MARKHAM ST. JUMP START IMPVTS. (CONWAY) (S)

AHTD JOB NO. 080566

Preliminary Plan Comments and Responses Summary

VERIFICATION OF 13 DESIGN CRITERIA

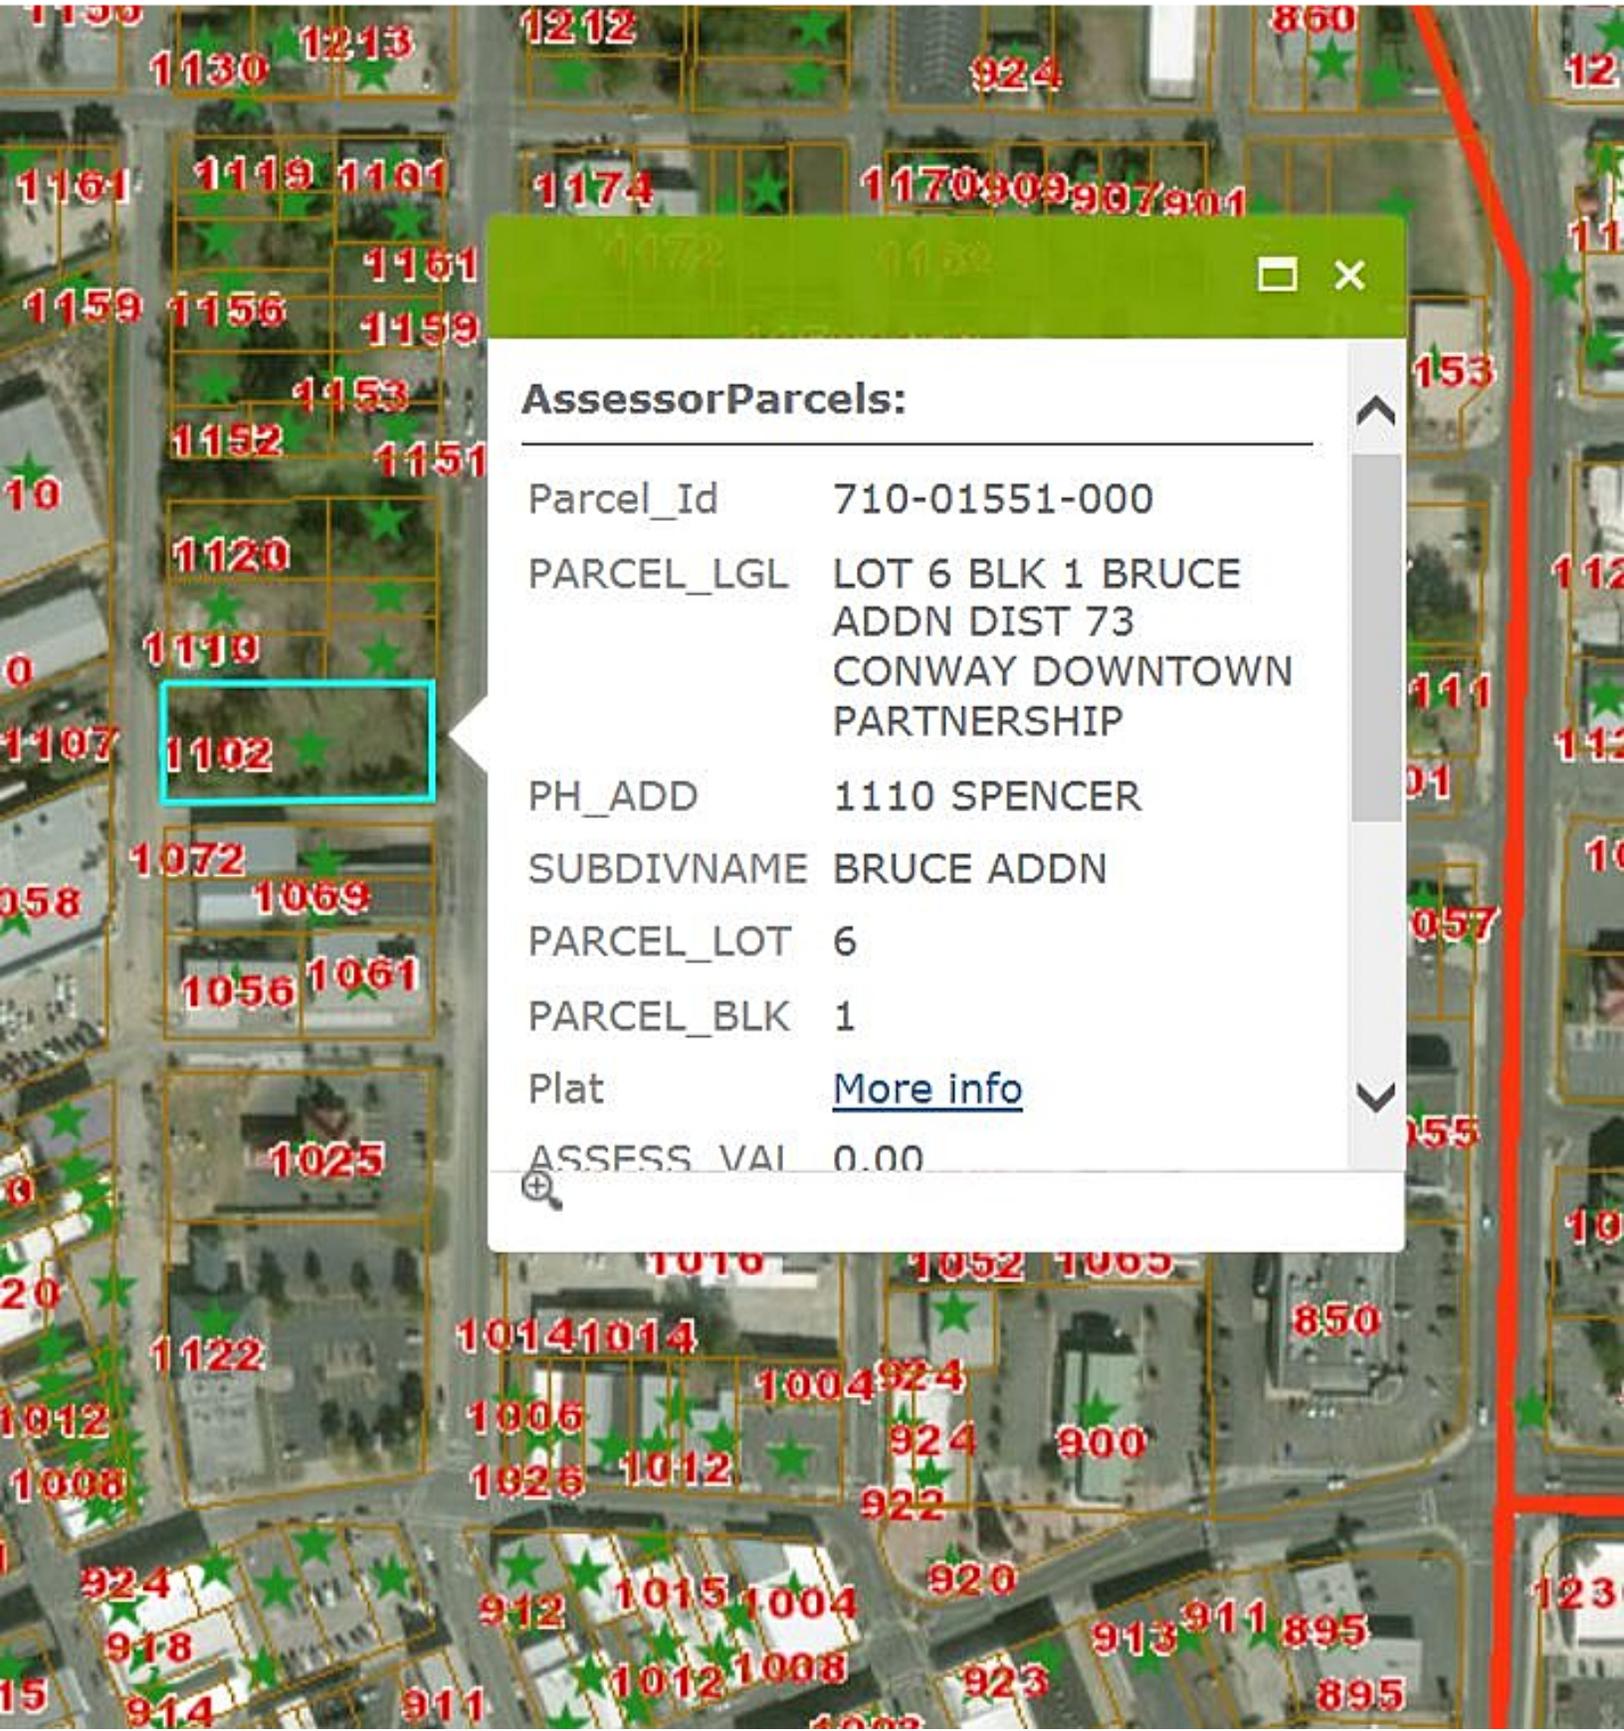
1. Design Speed : Not Provided (30 MPH?) ✓ See 90% Cover Sheet
2. Lane Width: 10' ✓
3. Shoulder Width: C.C.C. & G. ✓
4. Bridge Width: N/A ✓
5. Structural Capacity: Pavement Design Provided ✓
6. Horizontal Alignment: R=273' (Green Book, Low-Speed Urban Streets)? ✓
7. Vertical Alignment: $K_{crest,30}=19, K_{sag,30}=37$ ✓
8. Grade: 7% (Green Book, Collector Roads and Streets) ✓
9. Stopping Sight Distance: 200 (30 MPH) ✓
10. Cross Slope: 2% ✓
11. Superelevation: No Superelevation, Low Speed Urban Tables ✓
12. Vertical Clearance: N/A ✓
13. Horizontal Clearance: 1'-6" from Face of Curb ✓

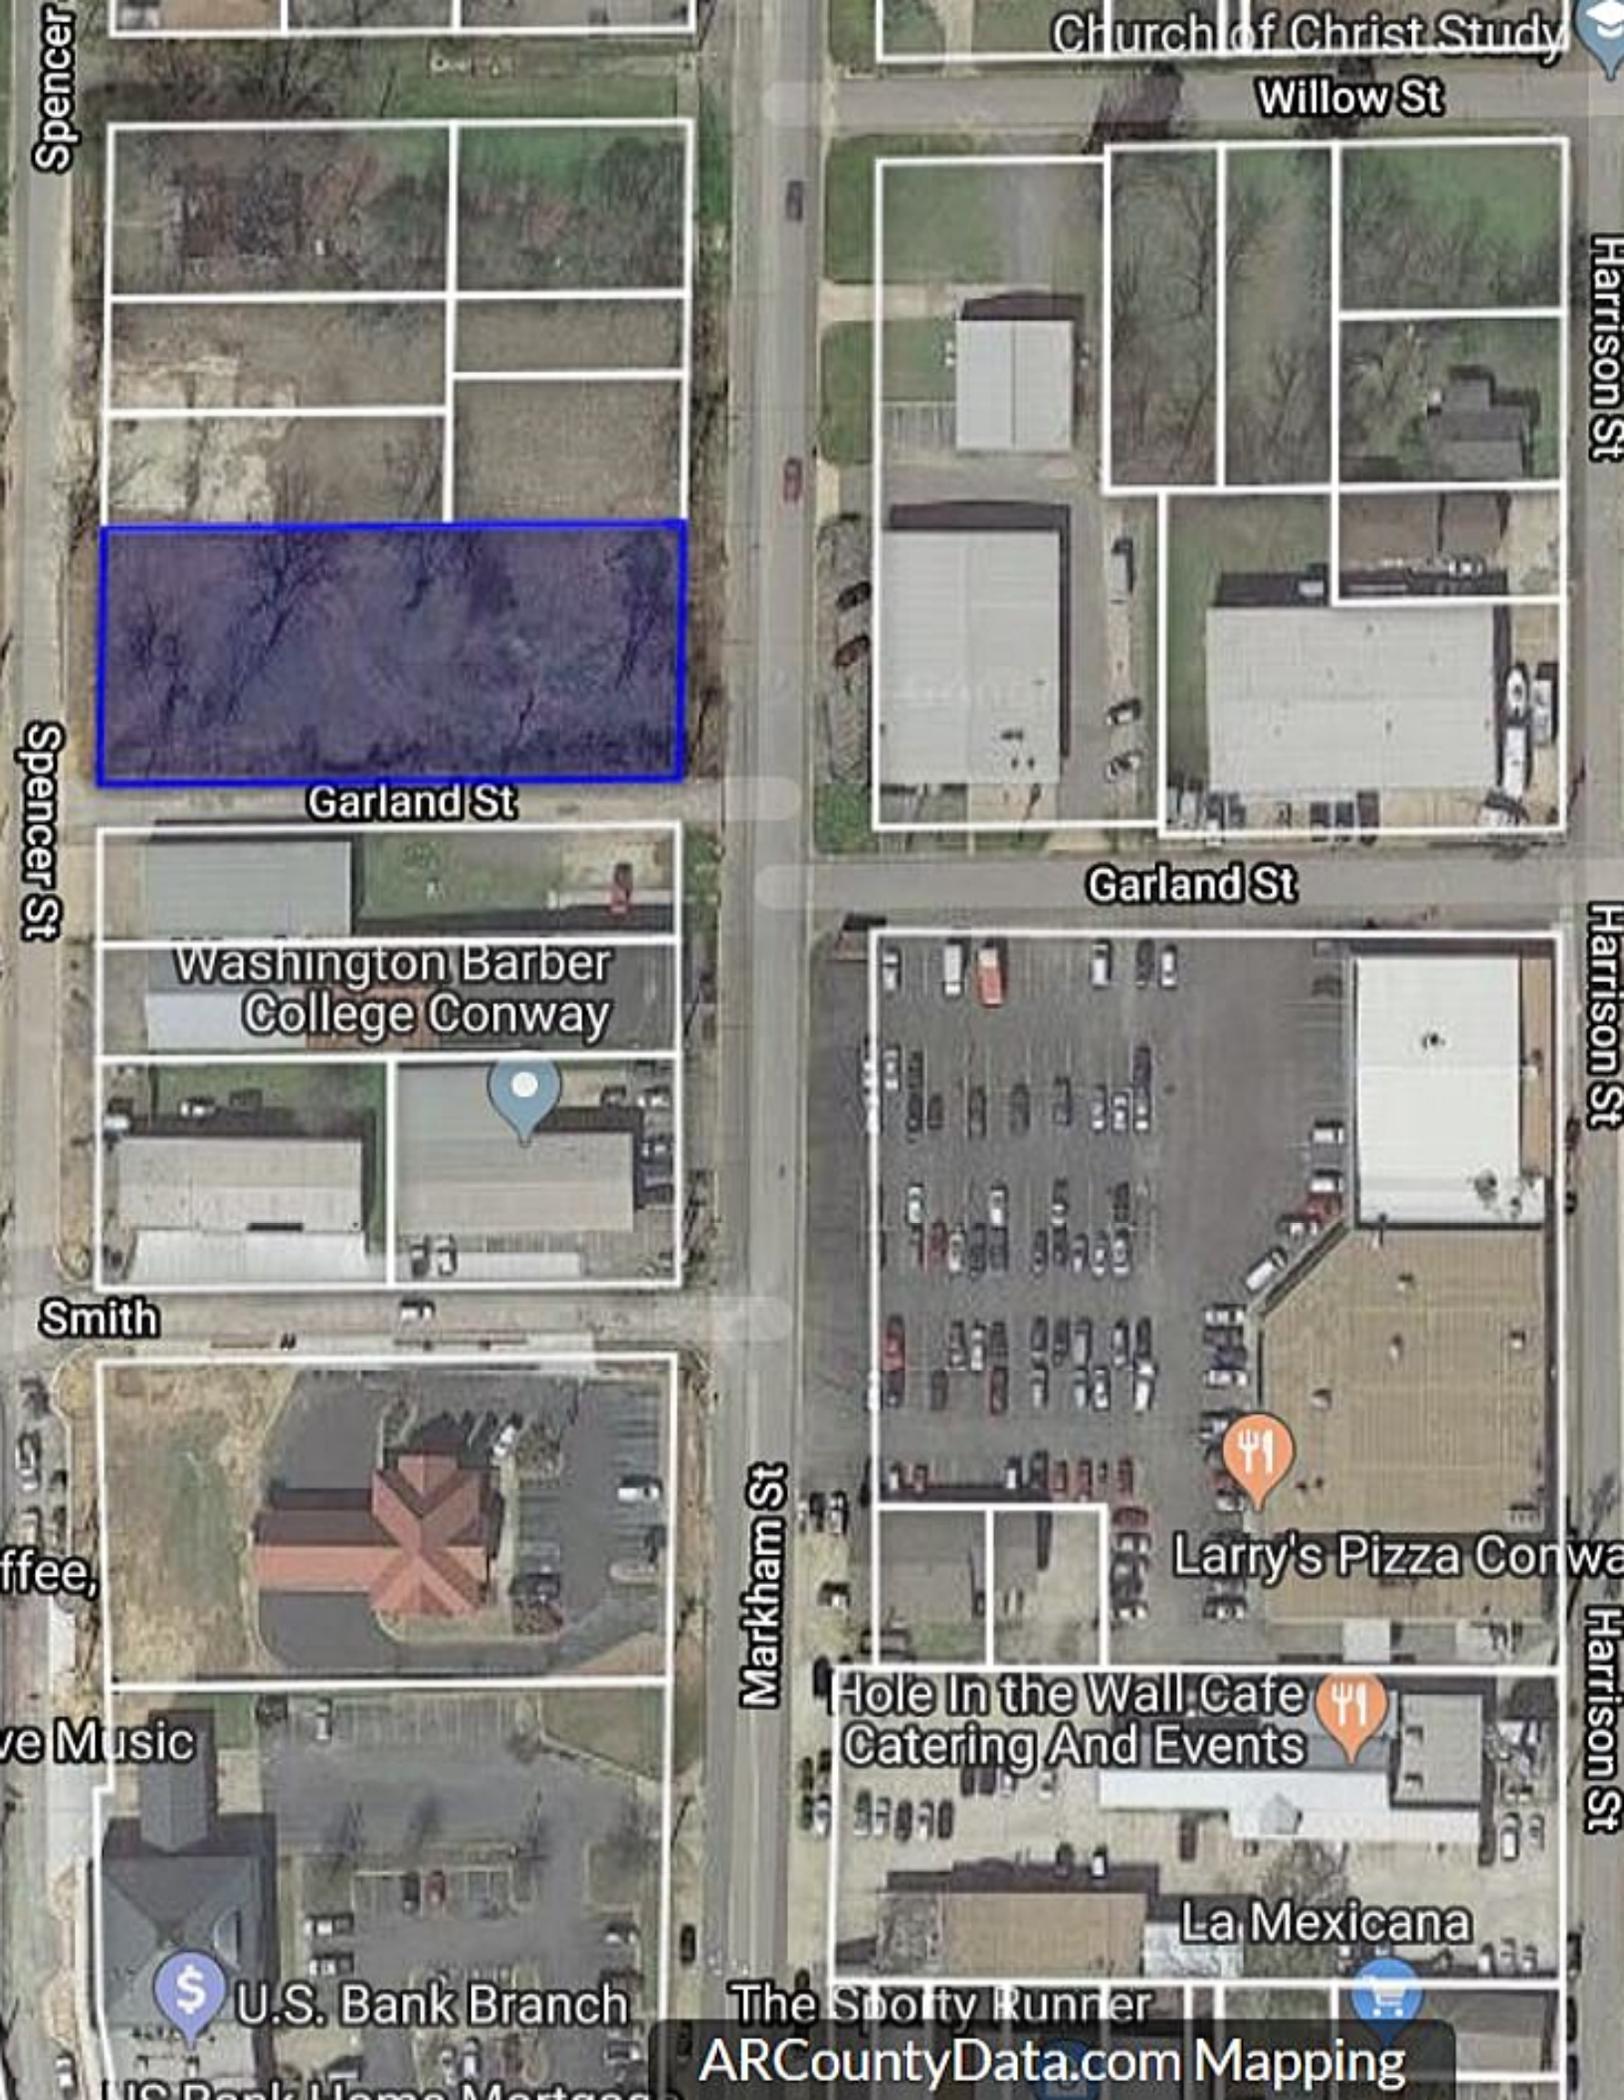
12. Is the drainage structure at +/- 33+25 LT. existing or proposed.

- ✓ This structure is proposed for future use as an outlet to a planned detention area by the City of Conway. This property is currently owned by the City of Conway. See attached parcel information. The pipe will be stubbed out and plugged for future use.
